**Historic Architectural Review Commission
Staff Report for Item 5a**

Application Number: H15-01-1528

Address: #1301 Whitehead Street

Description of Work:

Proposed Site Plan

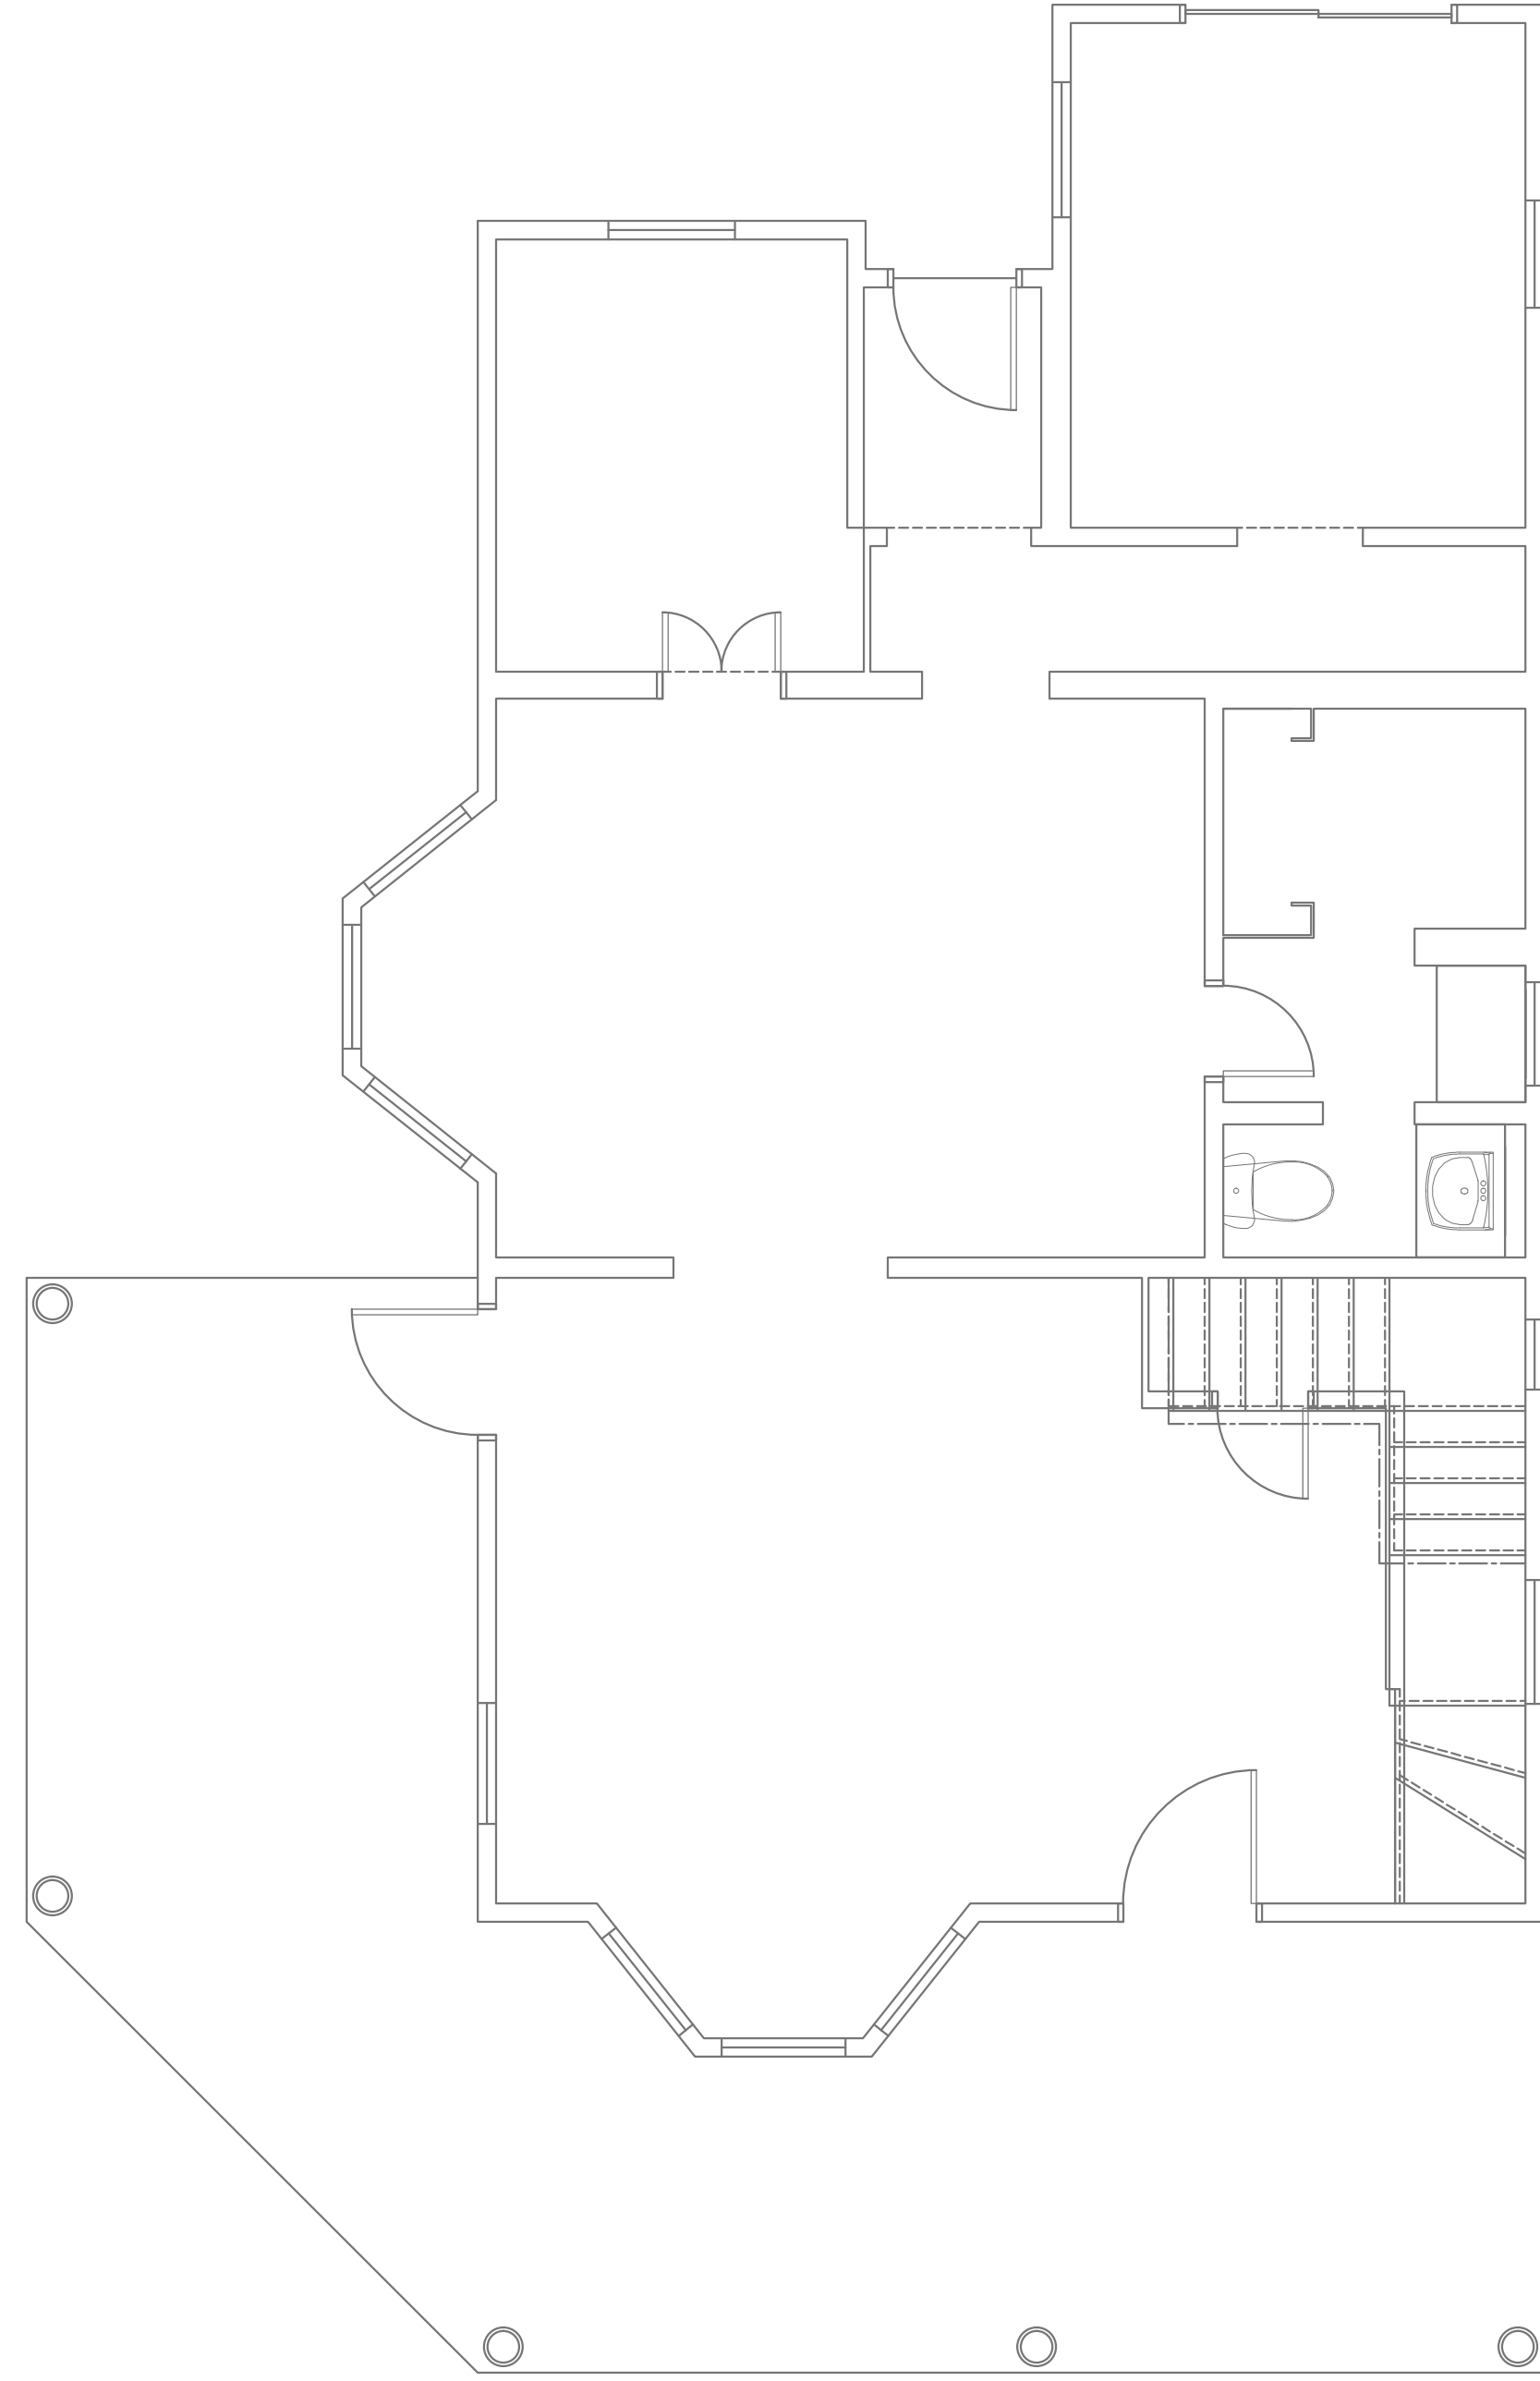
The plan also includes the relocation of the house, approximately 7'-6" towards United Street. The house will not be moved on its east-west orientation. This relocation responds to the new design and the need to create more room for the proposed side addition. Although the relocation will not interfere with the character of the adjacent house on United Street, it will be placed closer to the sidewalk, which will not be the historic distance and relationship the house have historically. (guideline 1-p.38)

The plan also includes a new accessory structure facing United Street. The new structure will have a hip roof, instead of a gable roof and will be relocated next to the northeast corner of the house. The structure will have a window facing United Street and will be elevated as the same level as the house. Staff does not consider this new building a reconstruction, since it is a different structure to what stands today. (p74) The guidelines for outbuildings recognizes repairs or restorations of pre-existing historically appropriate outbuildings, the new design does not meet this specific guideline. (guideline 8-p.40)

The design also includes a new swimming pool and deck, both on the rear portion of the lot and not visible from the streets. (guideline 3-p 40) Re-grading is also proposed.

Existing Front (Whitehead St.) Elevation

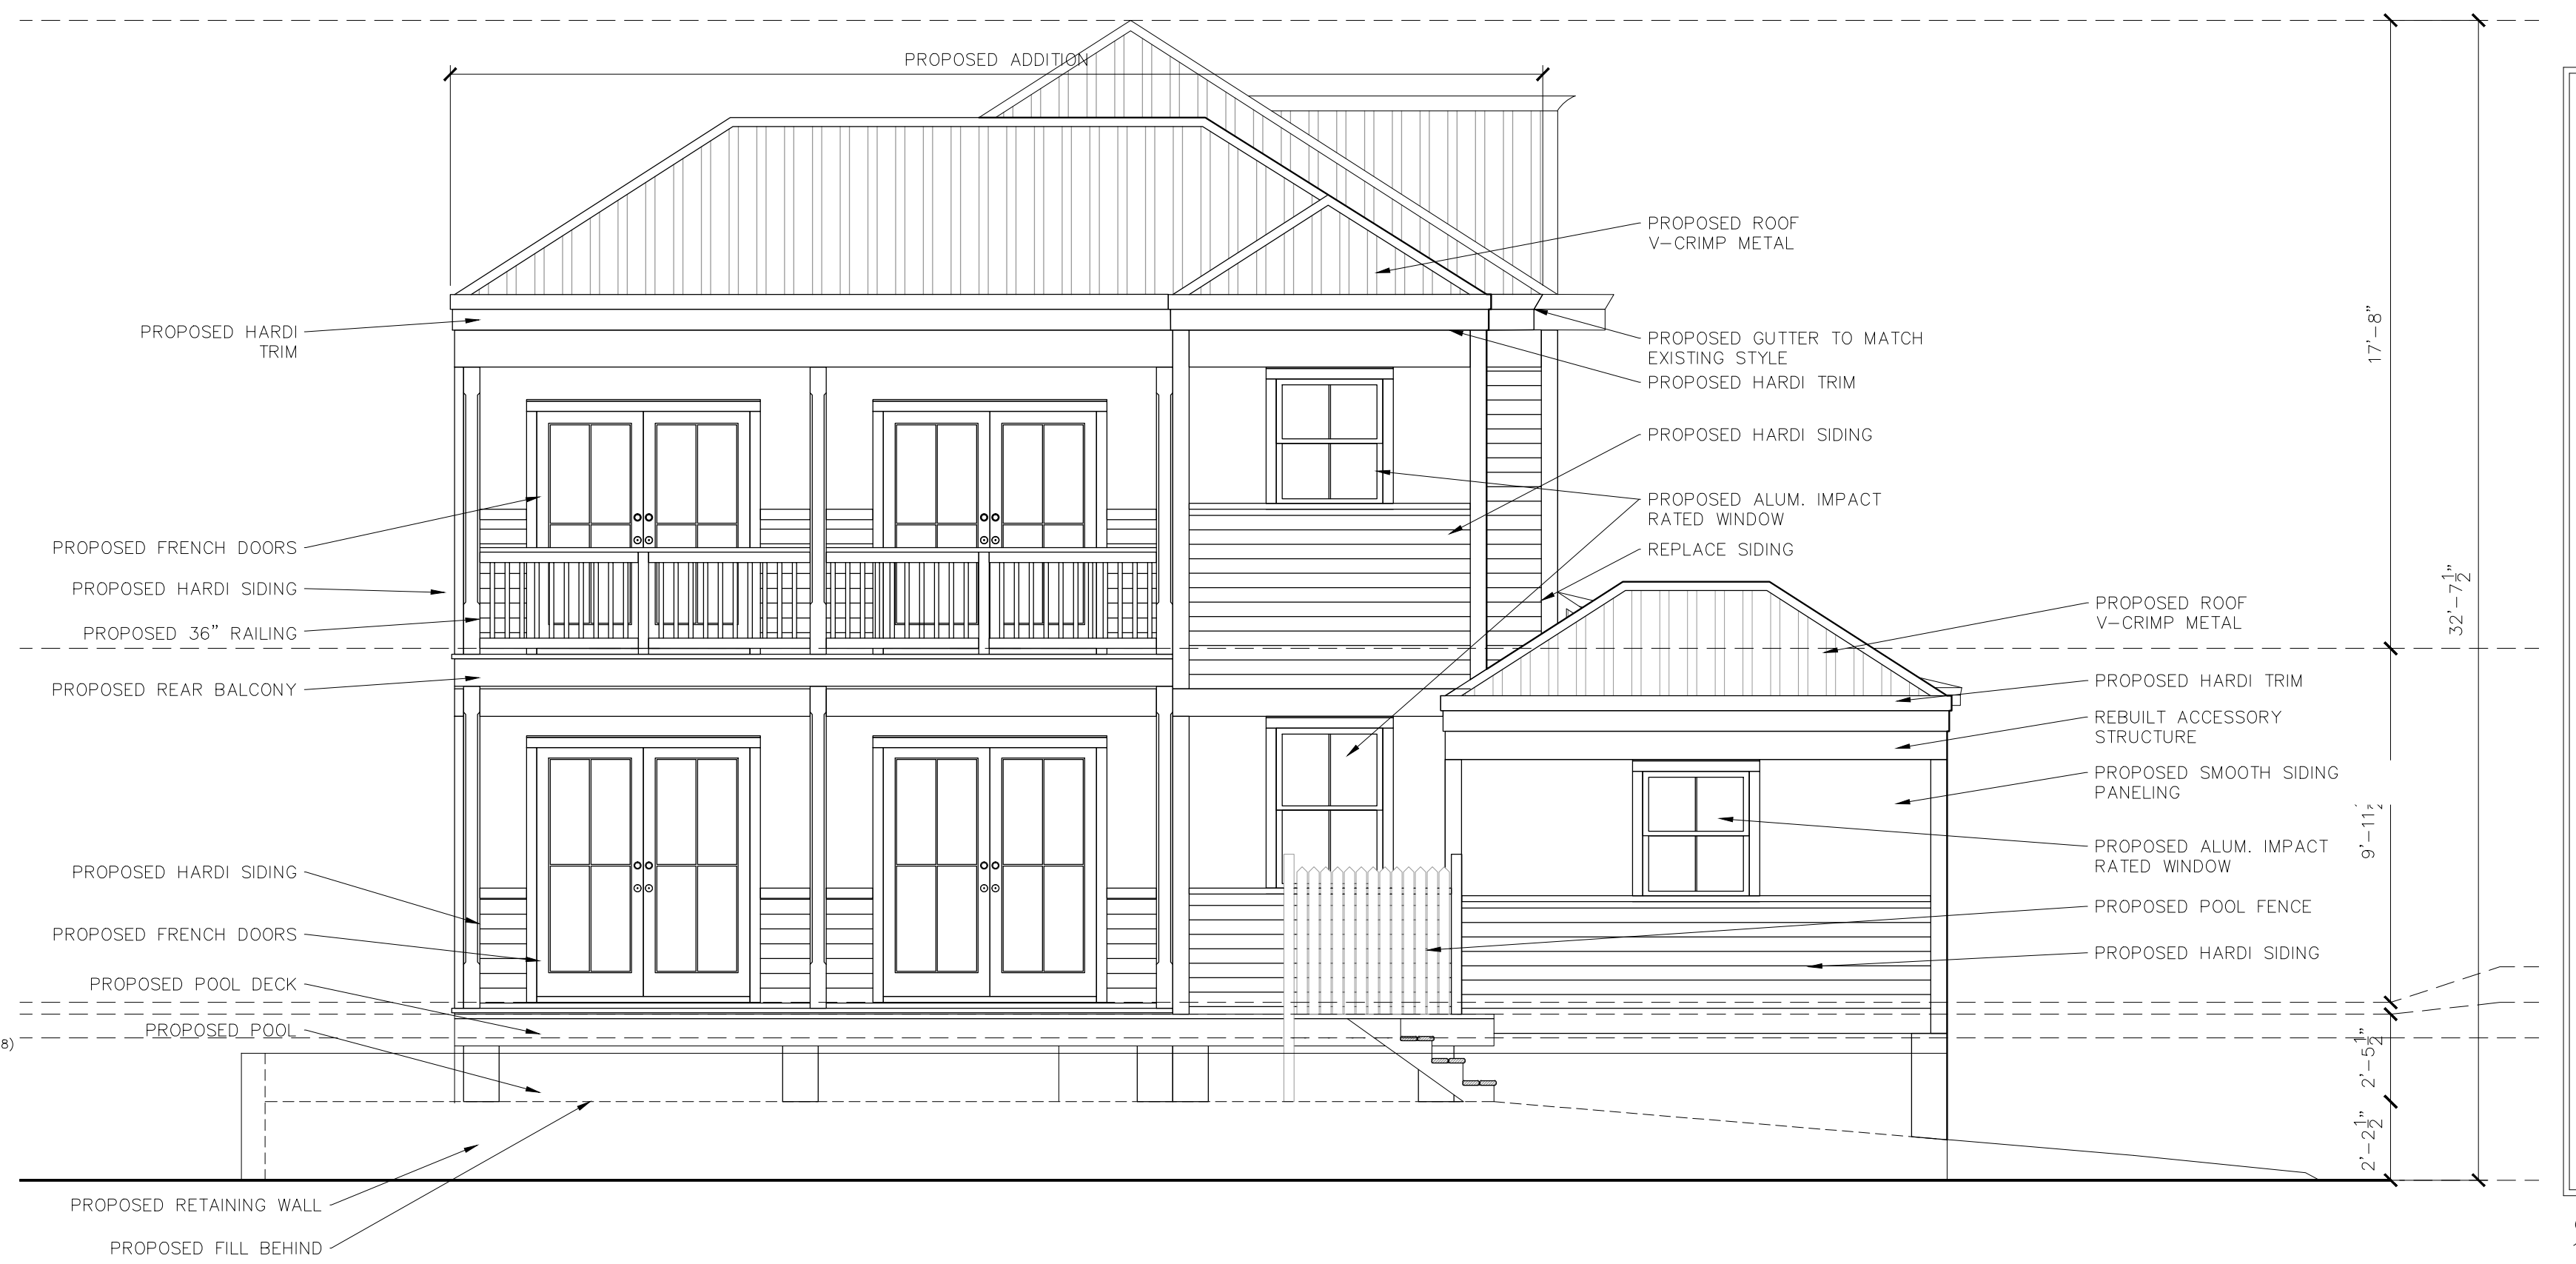
The historic house is proposed to be elevated approximately 2'-6" from its current piers. This request is due to flooding problems that the owners had experienced during heavy rains. By raising the house, the main building will be approximately 4'-3" taller than the adjacent house on United Street and approximately 2'-7 1/2" taller than the adjacent house on Whitehead Street. The proposed high transitions between the new additions and the adjacent house on United Street will make this change appropriate when referring to height and scale. (guidelines 3-4-p.38a) On Whitehead Street and due to the height differences on the existing four houses there will be no major visual impact that will interfere with the essential form and the integrity of surrounding properties (guideline 2- p.38). The design includes regrading of the front and side yards in order to make the footers visually lower.
